# UNITED STATES PATENT AND TRADEMARK OFFICE

10/554,451

<b>Office Action Summary</b>	<b>Application No.</b> 10/554,451	<b>Applicant(s)</b> ROODMAN ET AL.	
	<b>Examiner</b> Krishnan S. Menon	<b>Art Unit</b> 1797

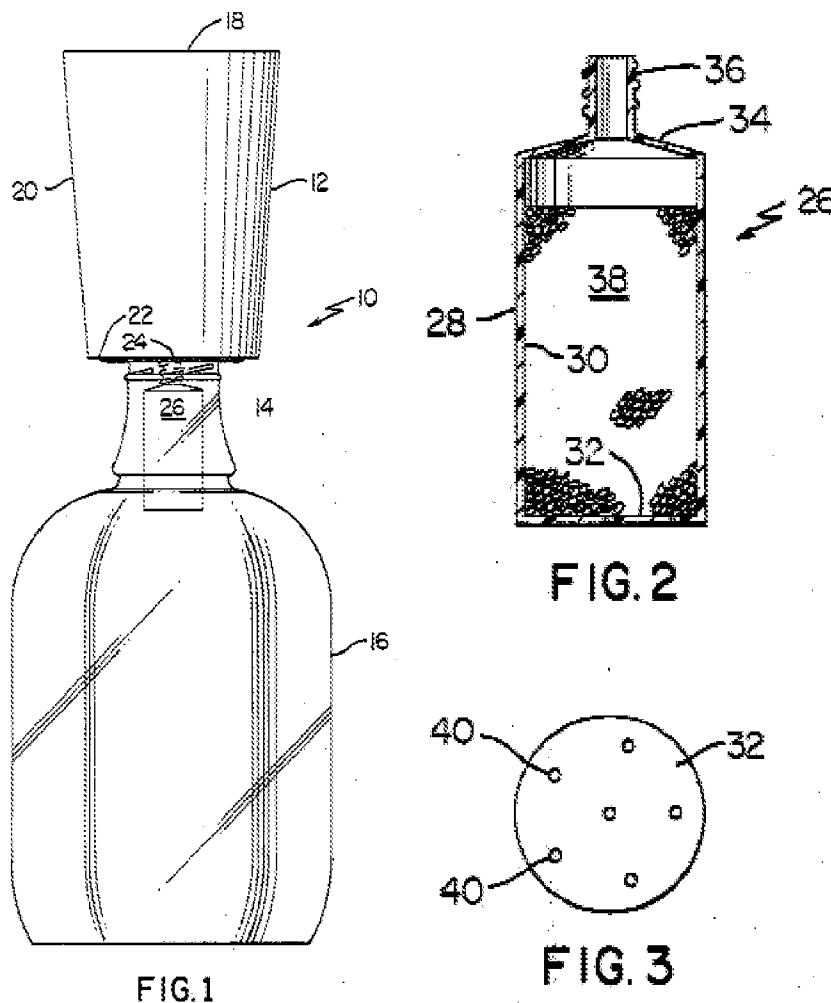
1. **Claims 1, 28, 48-51 and 54 are rejected under 35 U.S.C. 102(b) as being anticipated by Sway (US 4,419,235).**

Sway teaches a filter apparatus having a fluid input container (20) a filter with filter media 26 and a collection container 16 – see figs. 1-3 copied herein. Filter media

26 is activated carbon – see column 3, lines 38-62. References to wine in the claims are intended use, and are not patentable.

FIG. 2

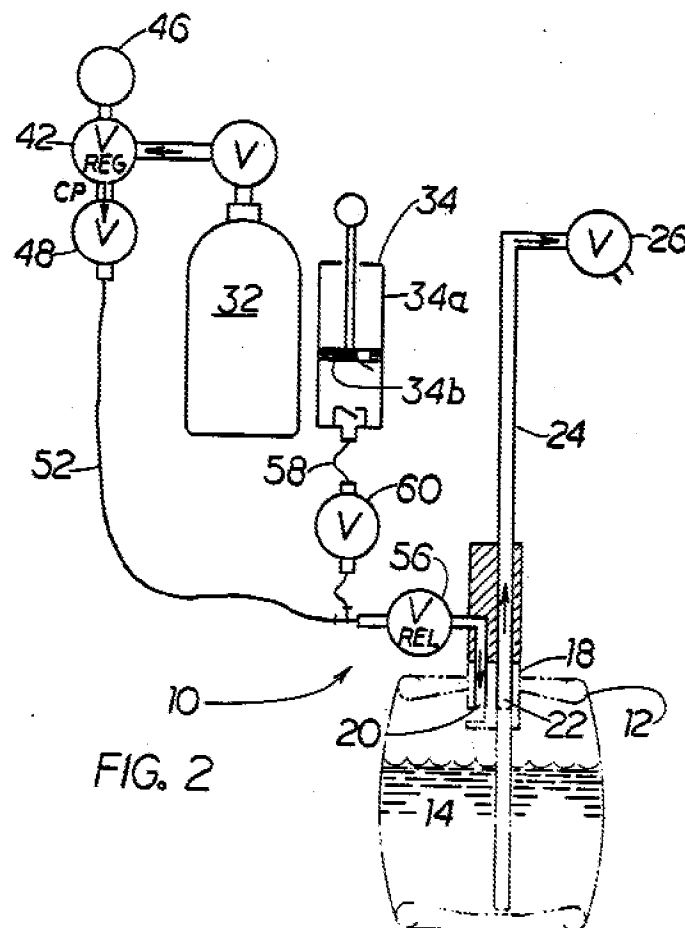
Claim 2: Sway teaches a the internal passage way connecting wine entry with wine exit through a filter as claimed – see the figure of Sway. However, Sway does not teach the pressure mechanism as claimed. Lowers teaches a pressure mechanism for dispensing fluids from a container - see the figure copied herein with all the structural details. It would have been obvious to one of ordinary skill in the art at the time of invention to have such a pressure mechanism as taught by Lowers in the teaching of Sway for the convenience of transferring or dispensing the liquid from the container and through the filter device of Sway. Such dispensing devices are also well known in the art (see for further evidence Shannon (US 4,624,391) which teaches a wine dispenser and Carr (US 4,454,967) – Fig %: a common drum pump.

Claim 3 recites a gas entry and pump mechanism to the pressure mechanism of claim 2. Lowers teaches both a hand pump (34) and a gas pump (32) mechanism for the dispenser. Claim 8 has a container with a neck portion – see container (14) has a neck portion (18), and a neck engaging portion – (19 and 19a – fig 1.)

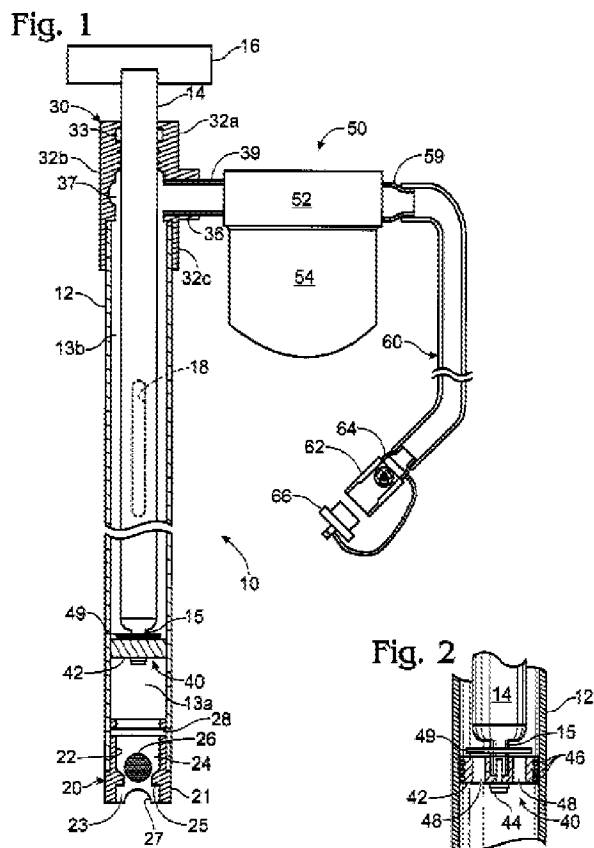
**3. Claims 1, 2, 8, 15, 19 and 28 are rejected under 35 U.S.C. 103(a) as being unpatentable over Walker (US 6,334,760)**

Walker teaches a filter apparatus as shown in fig 1 copied herein. The filter mechanism has a pressure mechanism including the pump and the conduits, filter (54) attached to the pump and a filtered fluid exit tube (60). Regarding the wine source with container and neck portion, the Walker device is meant for containers such as bottles and the pump (10) is capable of engaging with bottle necks.

The reference does not explicitly show a wine source and a filtered fluid container, but such would be obvious to one of ordinary skill in the art.
